### **STATE OF NEW HAMPSHIRE** DEPARTMENT OF TRANSPORTATION **BUREAU OF HIGHWAY DESIGN**

### **MEETING SUMMARY**

### **PROJECT:** BOW-CONCORD 13742 Interstate 93 Improvements – Part B

SUBJECT: **Public Informational Meetings**

Mr. Foote Concept

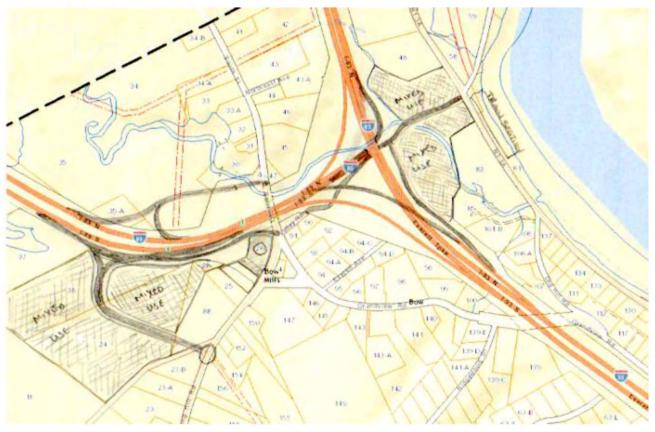
- One person preferred roundabouts at the Exit 1 ramp intersections.
- Mr. Foote presented a sketch of an alternate concept he developed (See attached).
